# WARRANTY BULLETIN

Wb99-19

SUBJECT: SECURING OF PARCEL RACKS

Model	VIN	PROPERTY CAR NO.
XL-40 & XL-45 Coaches Model Year : 1999	2PCL33495 <u>X</u> 102 <u>6834</u>	<u>-</u> 2PCL33490 <u>X</u> 102 <u>6837</u> - 2PCL33490 <u>X</u> 102 <u>6840</u>
	2PCL33496 <u>X</u> 102 <u>6843</u>	<u>3</u> - 2PCL33491 <u>X</u> 102 <u>6846</u> – 2PCL33497 <u>X</u> 102 <u>6849</u>
	2PCL33495 <u>X</u> 102 <u>6851</u>	_ 2PCL3349X <u>X</u> 102 <u>6859</u> - 2PCL33495 <u>X</u> 102 <u>6865</u>
	2PCL33490 <u>X</u> 102 <u>6868</u>	<u>3</u> - 2PCL33490 <u>X</u> 102 <u>6871</u> – 2PCL33491 <u>X</u> 102 <u>6877</u>

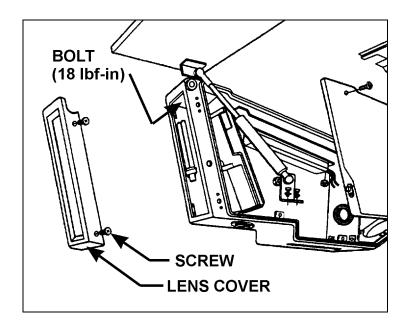
On the above-mentioned vehicles, some of the bolts securing the parcel racks may not have been properly fastened. Retorquing the bolts is necessary for proper parcel racks fixation.

- 1. Remove the four screws securing the lens cover (refer to figure 1). Remove the lens cover.
- 2. Locate the bolt securing the parcel rack (refer to figure 1). Retorque the bolt to 18 lbf-in (1.98 N·m).
- 3. Carry on with the fore-mentioned procedure for all bolts.
- 4. Reinstall the lens covers.
